From: [Scott Schierman \(USA - Casper\)](#)
To: [Linton, Ron](#)
Subject: [External_Sender] FW: Looking for three well locations
Date: Tuesday, July 25, 2017 2:56:41 PM
Attachments: [MU2 MU3 Restoration Map 2015 Rev1.pdf](#)

While reviewing the CR MU 2-6 restoration report, our reviewer cannot find some wells on scaled maps with appropriate MU boundaries:

Willow Creek Project

Mine Units 2 & 3

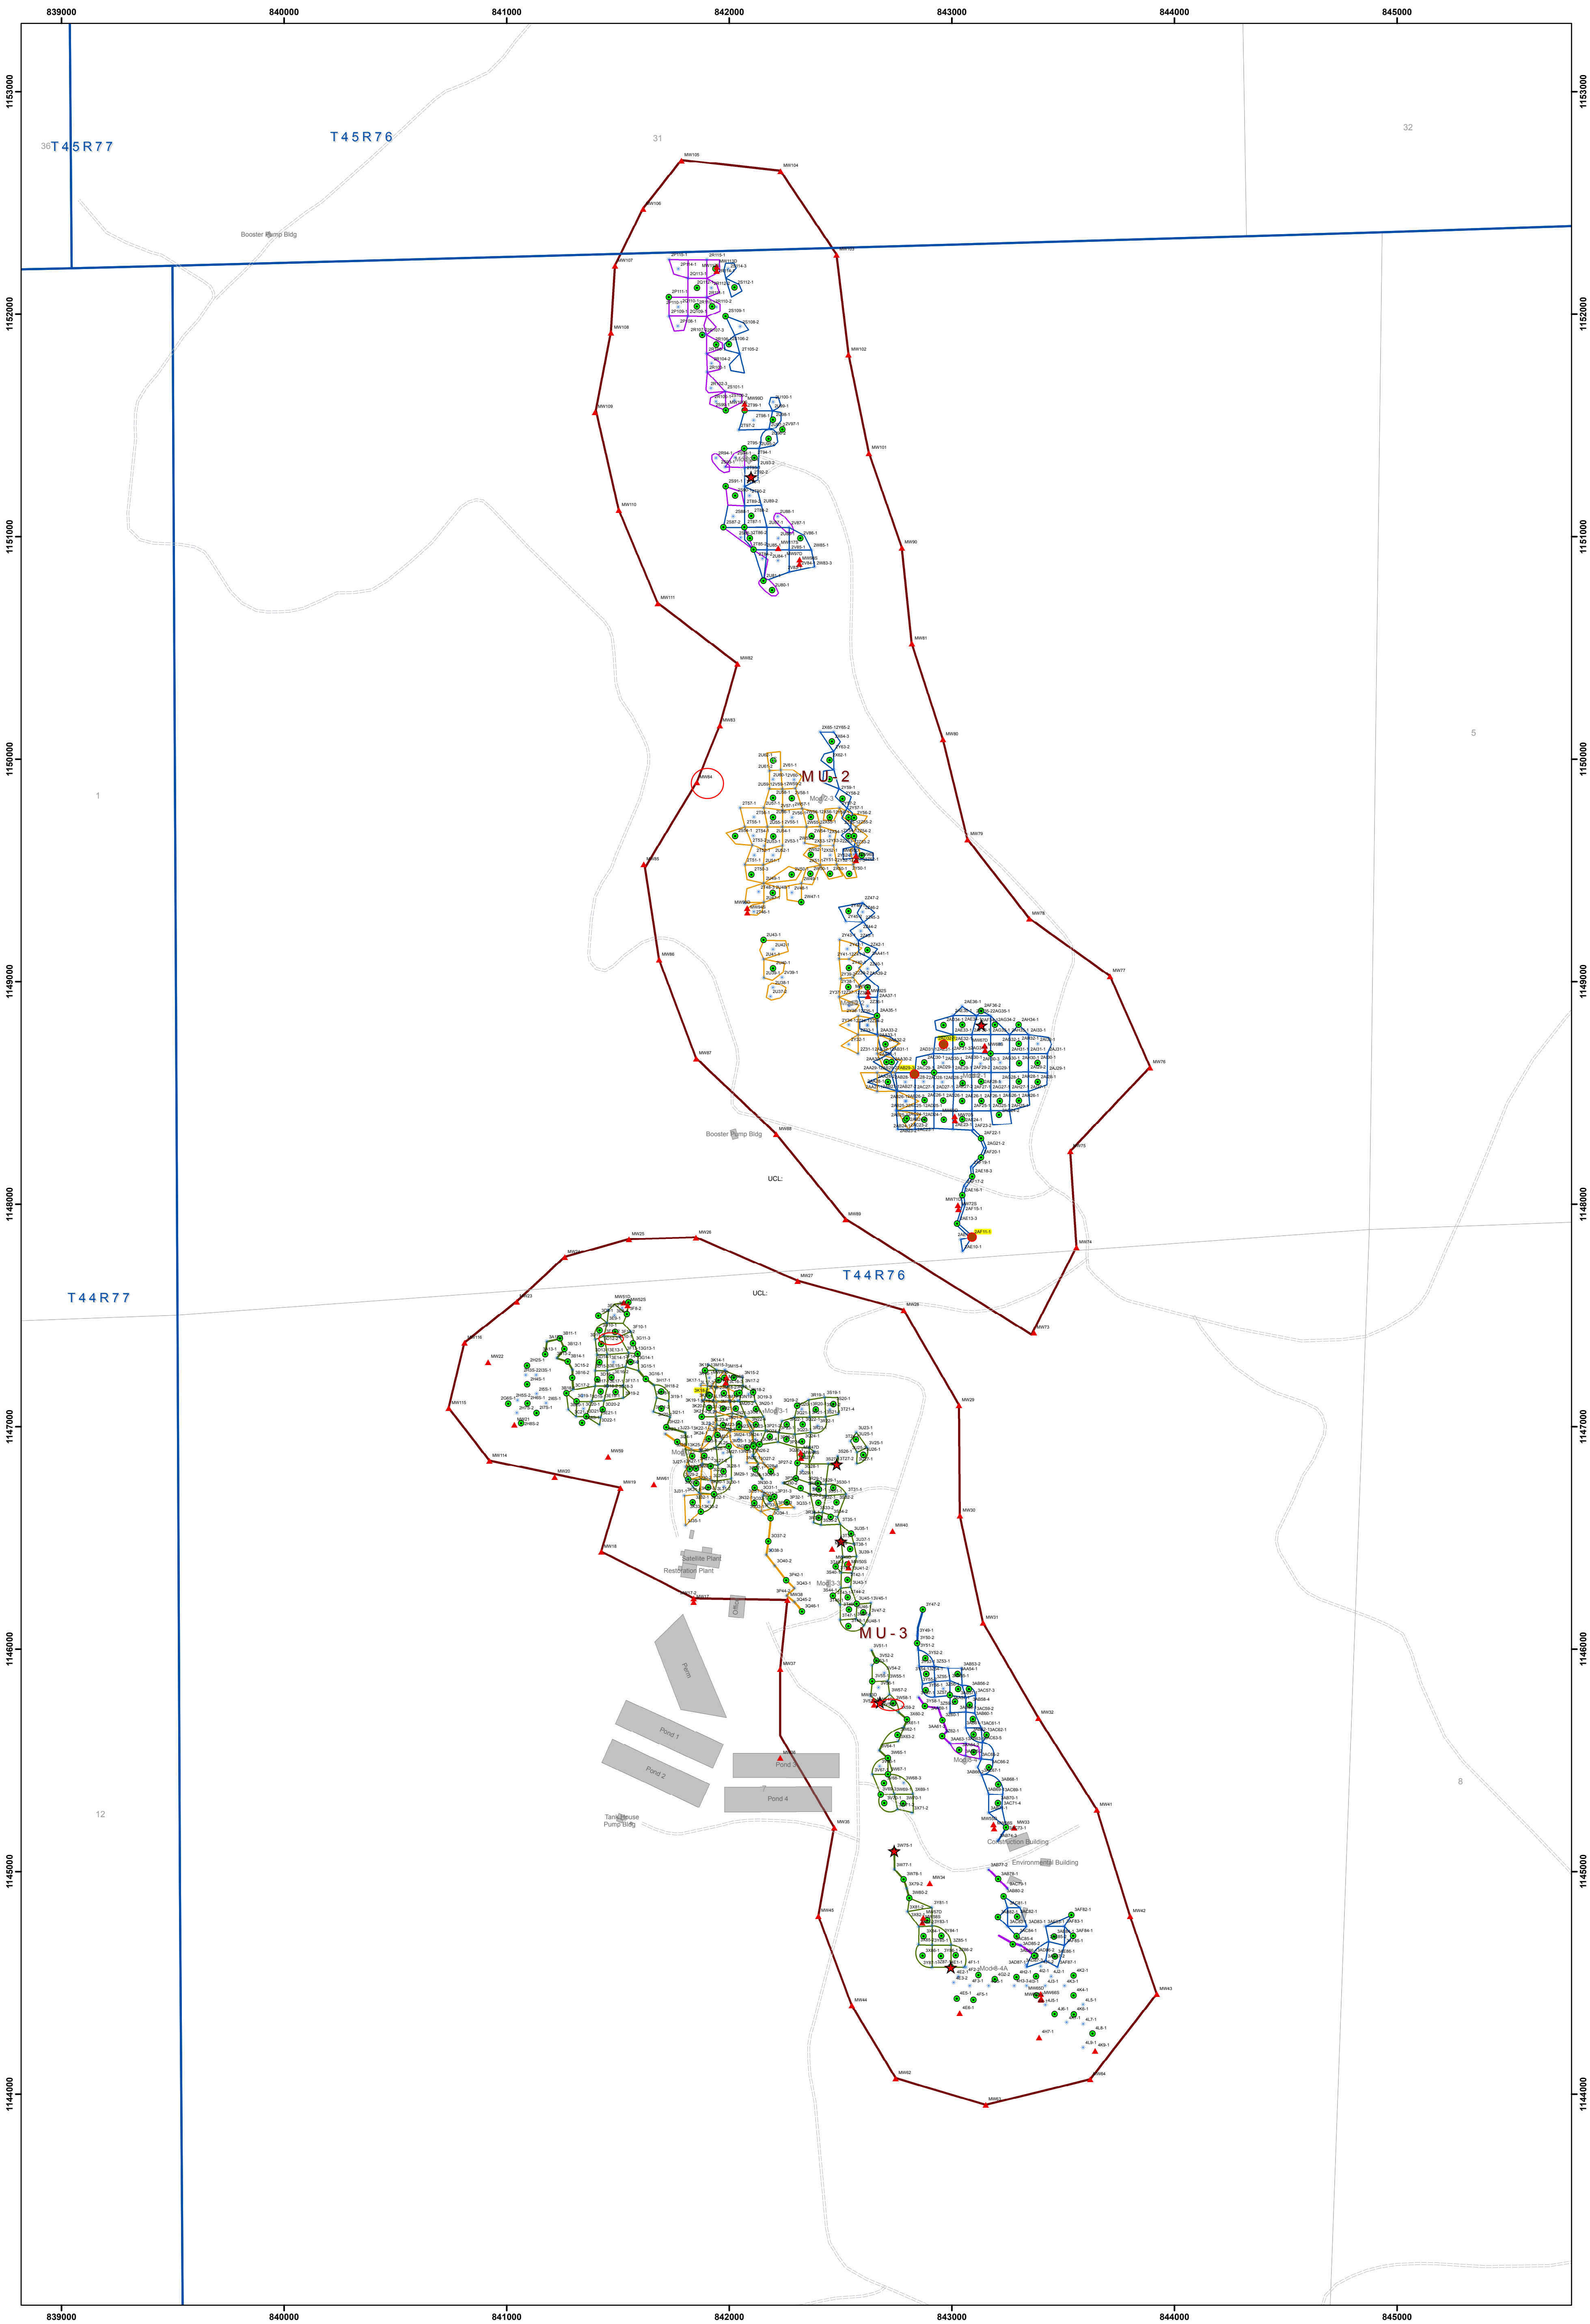
MU3 - 3V58-2

MU3 - 3D12-2

MU4 - MW-84

I have maps with all the perimeter wells, overlying and underlying wells, but we can't find these. Maybe these were production wells that were used for restoration. Do you if there are any maps with these locations that you have submitted in the past? Maybe Annual Reports, Semi-annual, etc.

Here is the information previously sent regarding the wells in Mine Unit 3. I have included a map which has 3V58-2 and 3D12-2 identified with a circle around them.

MU3-3V58-2 and 3D12-2 are production wells in Mine Unit 3.

MW84 has to be in Mine Unit 2 and is a parameter monitor well.
